**THE WAVE TRANSIT SYSTEM
MOBILE, ALABAMA**

**BUS SHELTERS INSTALLATION- PHASE 5,
PRE- BID MEETING**

ADDENDUM NUMBER 1

PROJECT NAME: Bus Shelter Installation- City of Prichard (Phase 5)
PROJECT NUMBER: MT-052-09
BY: Gary L. Jackson, Project Manager
Leon Bell, Jr., Grants Administrator

DUNLAP CIRCLE

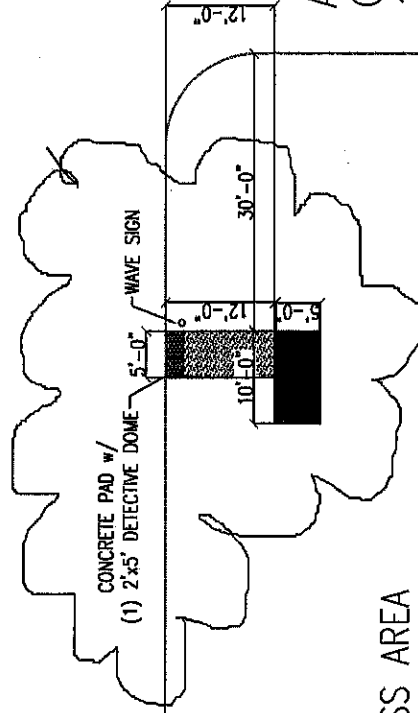
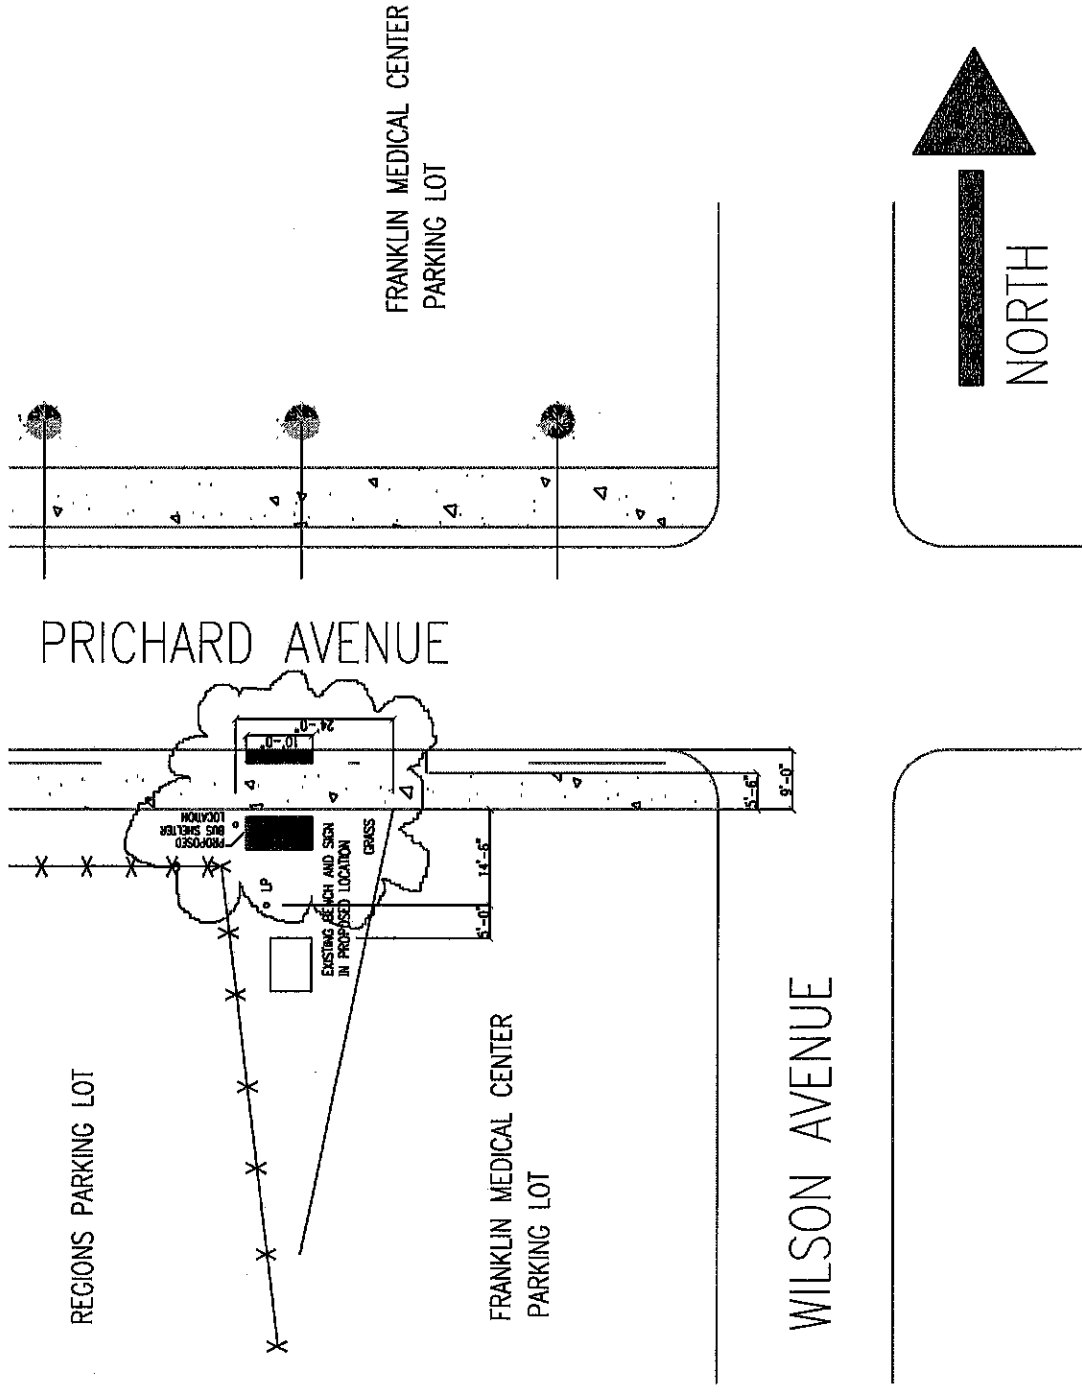
- Wilson Ave at Dunlap Circle
 - 5' x 12' concrete pad from shelter to street
 - (1) 2' x 5' detectable dome
 - See attached documents
- Prichard Lane at Wilson Ave
 - (2) 2' x 5' detectable domes to existing sidewalk
 - See attached documents
- 100 Black Men of Greater Mobile- 838 Main St
 - Relocate proposed location behind sidewalk
 - 5' x 11' concrete slab in front of sidewalk
 - (1) 2' x 5' detectable dome
 - See attached documents
- US Highway 45 at Lott Road
 - Dimensions for concrete pad for two shelters shall be 6'-0" x 22'-0"
 - See attached documents
